**ST. LUCIE PLANT
UNIT 1 AND UNIT 2**

**IMPROVED TECHNICAL
SPECIFICATIONS CONVERSION**

**ITS SECTION 3.3
INSTRUMENTATION**

**Current Technical Specifications (CTS) Markup
and Discussion of Changes (DOCs)**

Figure B 3.3.1-1 (page 1 of 1)
Functional Diagram of the Two-Out-of-Four Logic and RTCB Configuration

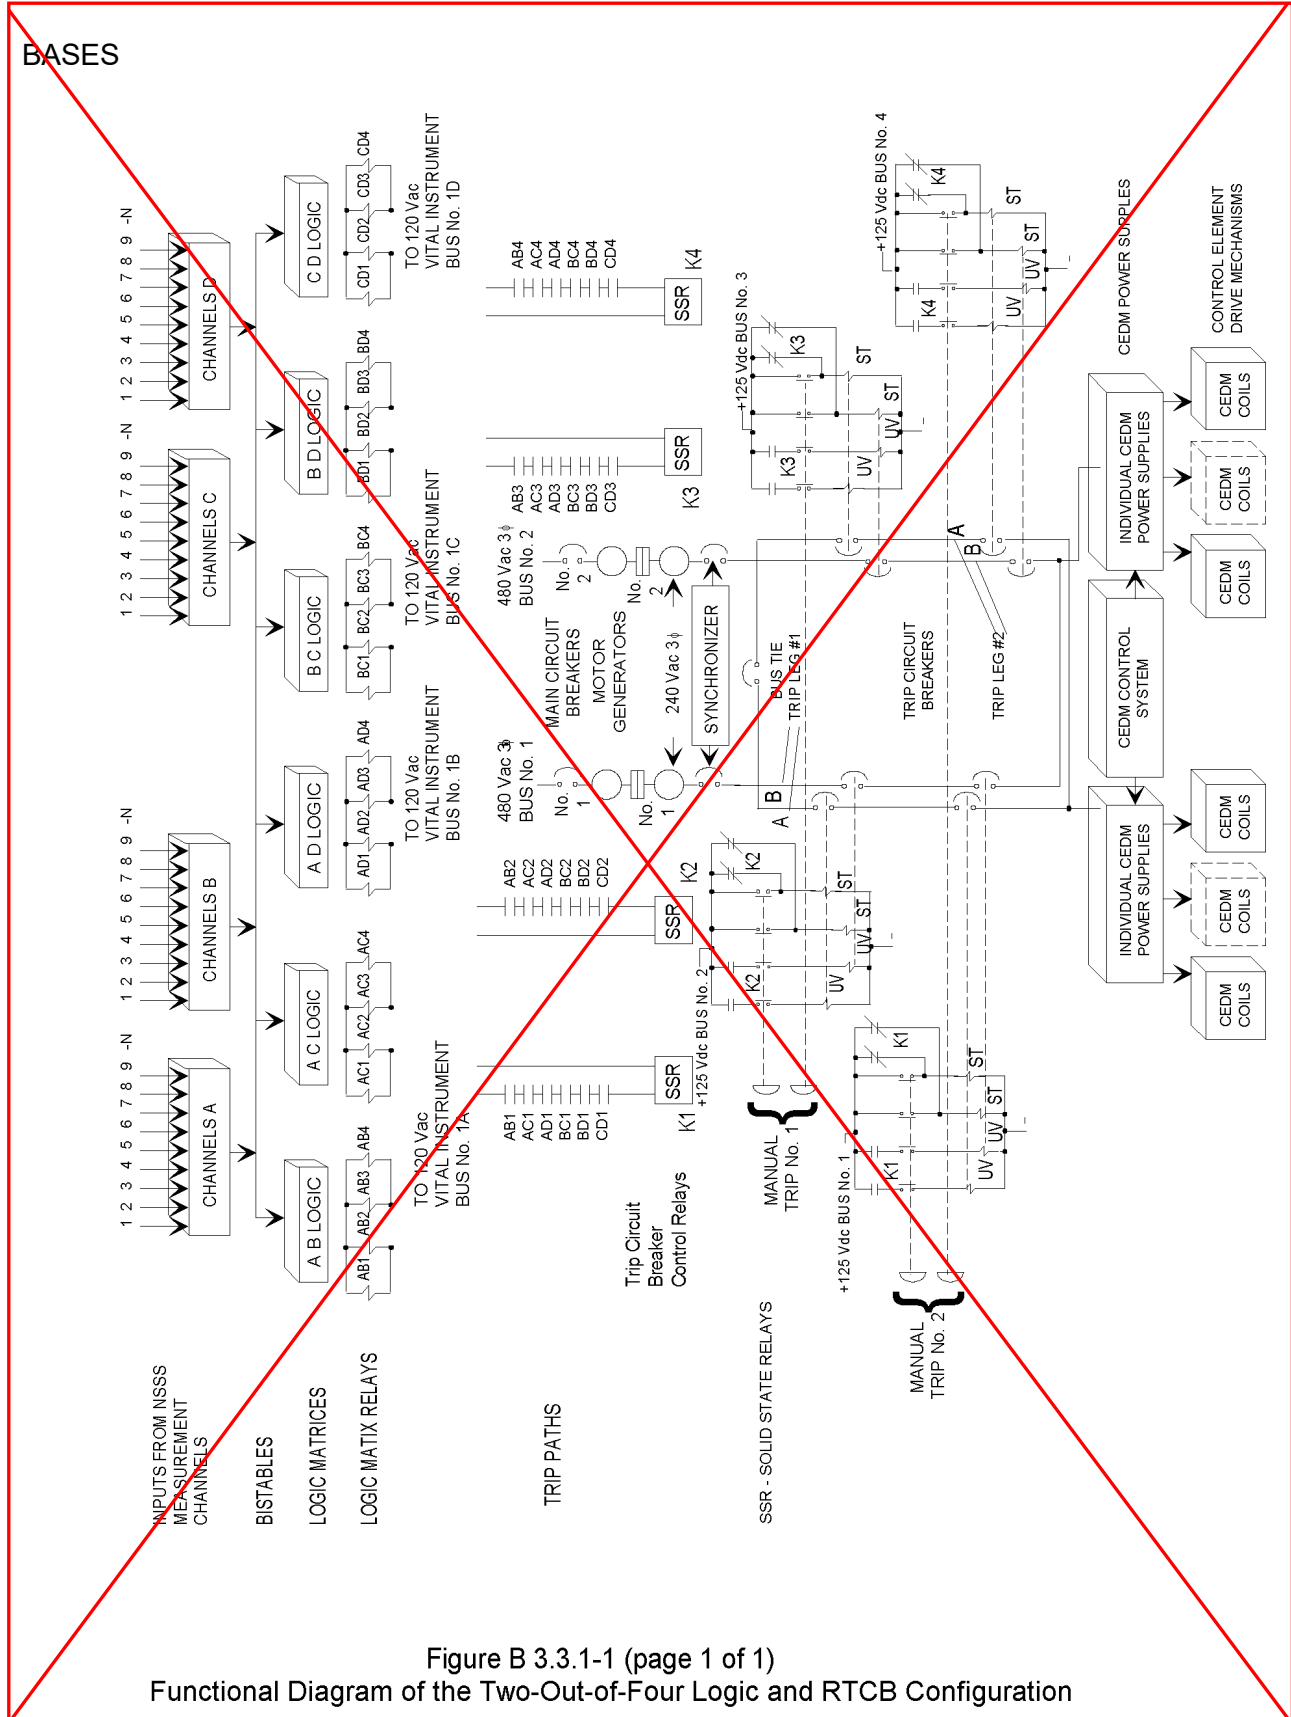
5. Figure B 3.3.1-1 was removed from the ITS 3.3.1-1 Bases because the figure is included in the UFSAR.
